Comments on #REZ-26-0002 - Planning & Zoning: Rezoning (Map Amendment)

Application Number: #REZ-26-0002
Application Type: Rezoning (Map Amendment)
Date: March 26, 2026
Address: 1101 Averette Road

EXHIBIT FOR
AVERETTE ROAD
SUBDIVISION
1101 AVERETTE ROAD
ROLESVILLE, NORTH CAROLINA

Dwg No. EX 1.0

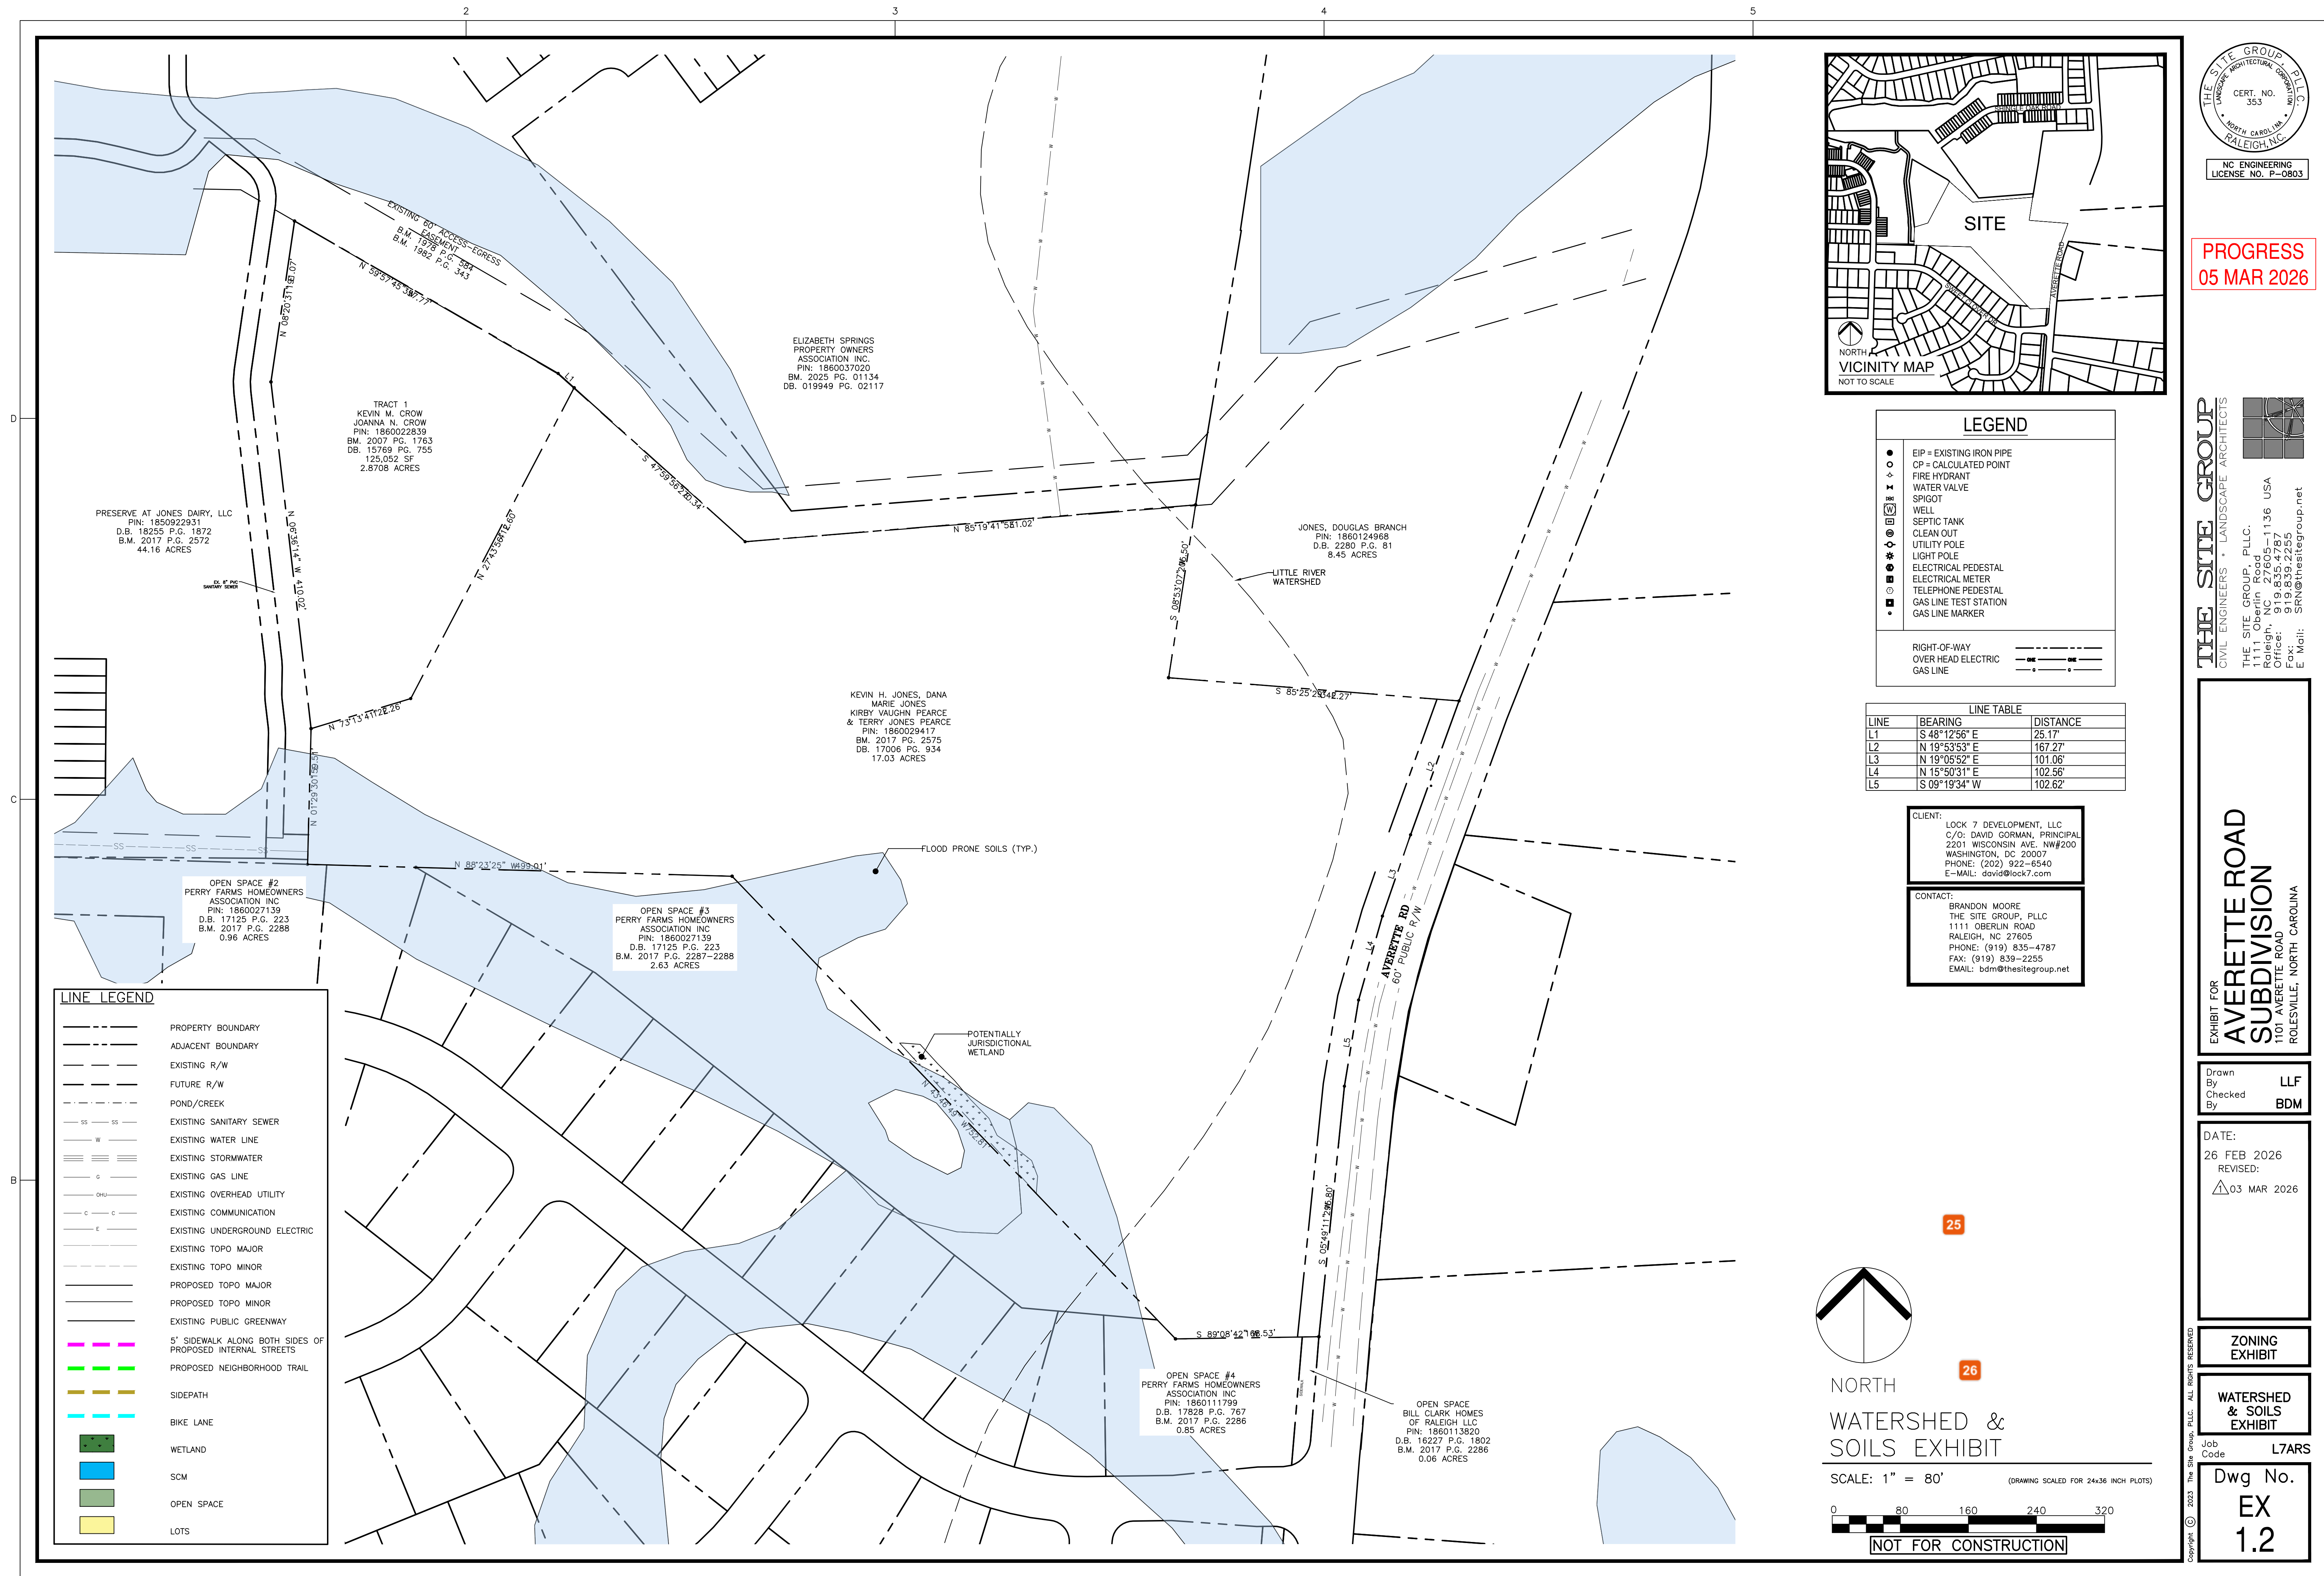
Planning Staff have been in email communication with Applicants throughout March on various aspects of the proposed development shown in this Concept plan - make all revisions as discussed, in particular LDO 3.1.3/Table 3.1.3. Special Standard - "No more than 15 gross acres may be assigned to attached or multiple family uses." Site Data Table should be very clearly and expressly denoting the proposed acreage of the RH-CZ zoning district and the GC-CZ zoning district (matching separate zoning boundary survey and field notes/metres & bounds description documents of the same).

In Typical diagram - REvise the presumed Decks to match Planning Directors decision on permitted Encroachments into Building Setbacks.

Typical Diagram - regarding shown 5' Side (external) Setbacks. LDO 3.1.3. Side Setback is "10' End Unit" and both Units are "end units". Staff identifies this conflicts w recent LDO Amendment to reduce Building Separation for 3 or less Attached Units to 10', essentially making it impossible to utilize a 10' Building Separation when each building must "setback" 10' from its' own lot line. Please discuss with Staff.

Overall - increasing the size of the GC district is suggested to avoid questions on the practical benefit of developing less than half an acre into a viable commercial business (esp when placed in a corner with both Street and Perimeter Bufferyards occupying a significant amount of the land area).

Typical Diagram- Deleting this is advisable as the nature of LDO 3.3 Conditional Zoning does not allow alterations less than the minimum, and hence a diagram expressing the minimum Standards is unnecessary (in this instance).

Please show RH and GC areas to be rezoned for mapping purposes.

Identify and note the 15 acres (max) allocated to single family attached uses.

Add "Permitted" before 'Density'

Re-Phrase to "Proposed Density/Max Number of units"

"Coverage Area" - does this mean 'Minimum Lot area' ? If so, change to "Minimum Lot Area" which is 2,000 SF.

A bike lane needs to be on the west side of Averette Road. See page 106 of the Town's Greenway Plan:
https://www.rolesvillenc.gov/sites/default/files/uploads/rolesville_greenway_plan_final_apendices_july2022_1.pdf

FYI comment - The Town cannot require that this trail be paved, but it is strongly preferred that it is paved so that all Town trails and connecting trails are as ADA accessible as possible

So by committing to minimum lot dimensions of 30' wide and 100' deep, commitment is to minimum 3,000 SF lot area - write this as "Minimum Lot Area: 3,000SF". This is thus a voluntary condition to be less (actually larger) than the minimum lot size, which is a concession of sorts.

The proposed trail crosses a buffered stream and the connection to the town's trail should be amended.

Please add rezoning application number, REZ-26-0002 to the title block.

See Comment on Typical Regarding the 10' End Unit side setback dimensions.

ADT on Averette Rd would require a left turn lane into the site. Proposed access would be restricted to right-in/right-out otherwise.

Revise GC height to "Max: 42'; Design Alternative to go up to 50' "

GC maximum building height is 42' by right and up to 50' with a Design Alternative.

Until the RH District acreage is clearly delineated, calculating Required Open Space (which is 15% for RH, and 5% for GC). The "types" of open spaces may frankly be too much detail at concept plan stage - Staff is OK if you remove that data and drawing details. Generally showing where construction development will go (Yellow, Orange), where open spaces (ostensibly minimally disturbed) will be (Green), streets are streets, etc. is sufficient.

expand to "Watershed Overlay District" if not also citing LDO Section 4.2. You may want to connote it as "Non-critical area" as well to be fully specific as to what it is; what it means is beyond this drawing.

Revise - this application is REZ-26-0002, and rename to "Rezoning Concept Site Layout" please.
